Case #H 92-172 Meeting Date January 11, 1993  
Project Address 665 W. San Francisco District Westside-Guadalupe  
Agent Thomas Lechner Address 435 S. Guadalupe Phone 986-1583  
Owner Veronica Trujillo Address 665 W. San Francisco Phone 983-8595

**PROPOSAL:** Install pitched roof to front of building; add second story to rear of building. Tabled at 12/14/92 H-Board meeting.

-----  
CASE #H- 92-172 ADDRESS 665 W. SAN FRANCISCO

DATE: November 23, 1992  
TO: Historic Design Review Board Members  
FROM: Mary Grzeskowiak, Urban Design Review Specialist  
RE: CASE #H- 92-172 ADDRESS 665 W. San Francisco

PROJECT TITLE  
 2ND FLOOR PLAN

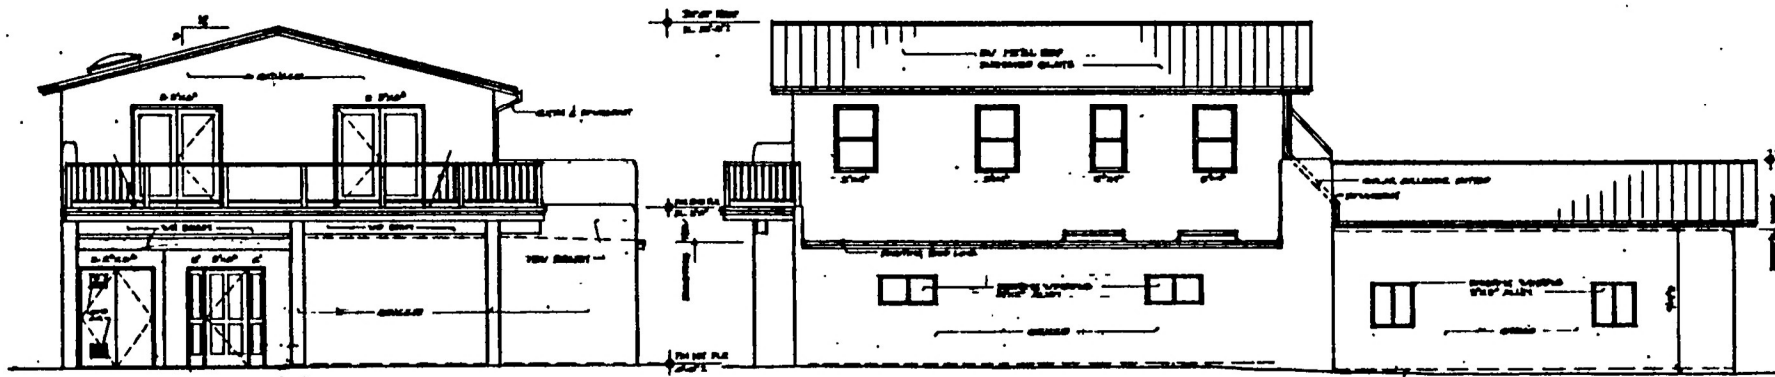
The zoning department brought to my attention that the West Deck was in violation to the zoning setback requirement of 10 ft. from the property line for second story use. Therefore please note on the revised drawings that the west deck has been deleted.

SHEET TITLE  
 EXTERIOR ELEVATIONS

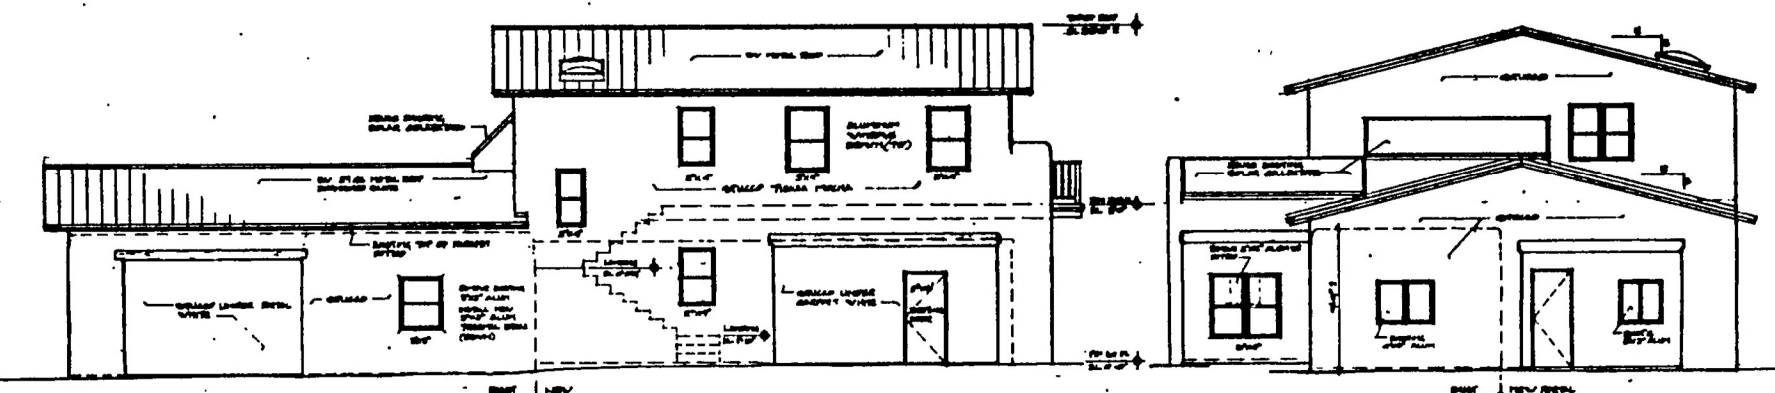
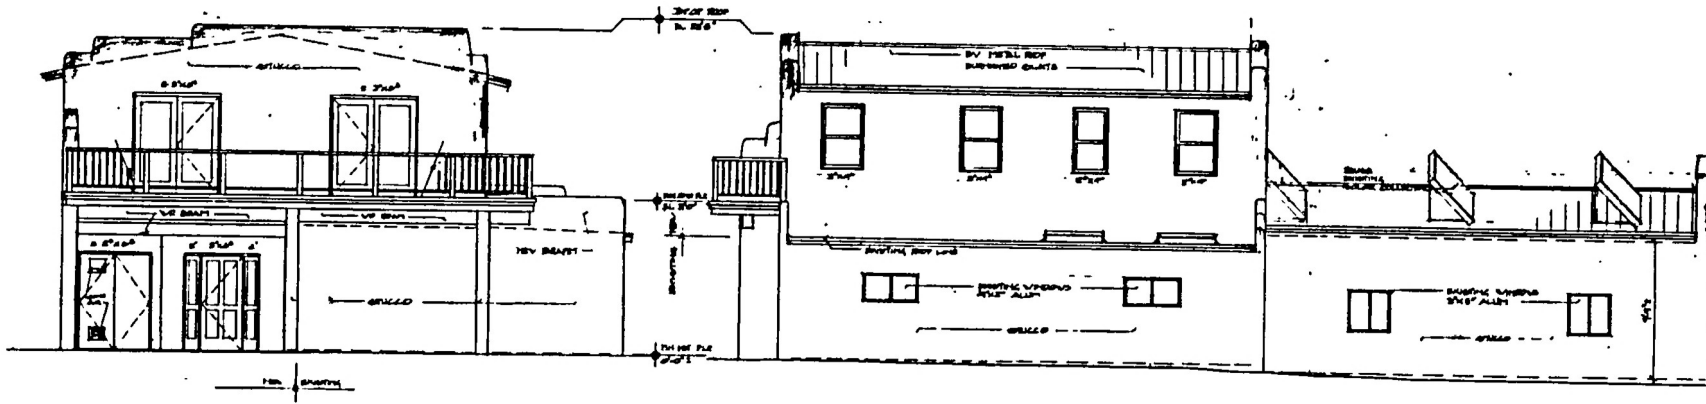
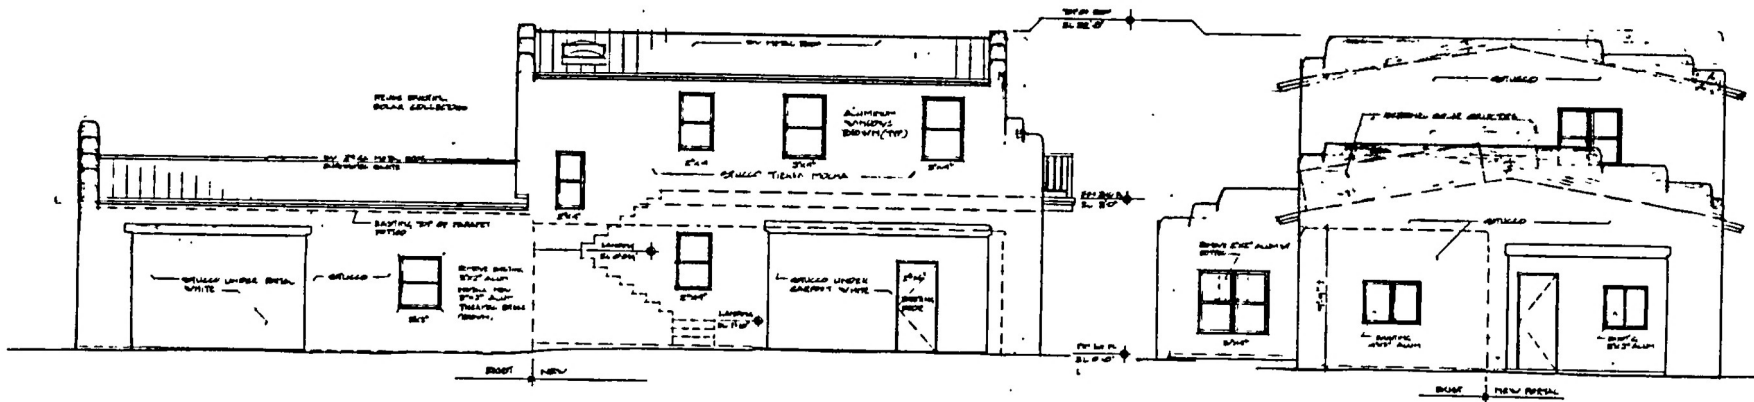
The applicant has provided additional revisions to his submission that includes the addition of a pitched-roof second story on the building. The height of the front portion has been revised to measure 20' from grade to ridge and will house attic space and a bathroom facility. The height of the rear portion has been reduced by over a foot and will measure 21'6" from grade to ridge.

The roof has also been revised to include dormers.

Mr. Lechner clarified for the chair that the long, narrow rectangle on the south elevation was one of two solar collectors in the design.

Mr. Lechner described the second solar collector for the chair, who commented that both would be very much visible on San Francisco Street. Mr. Lechner agreed, but said the problem was that integrating it in with the slope to meet code would face it in the wrong direction. The chair commented that perhaps a parapet and flat roof should be attempted instead. Mr. Lechner replied, "The problem is, because of the maintenance and the longevity and the problem with the owner, it would actually be a hardship." The chair asked Mr. Lechner if he was saying that this was a hardship situation and Mr. Lechner responded, "For the collectors, yes."

Ms. Rios expressed concern about the solar collectors and their general appearance.
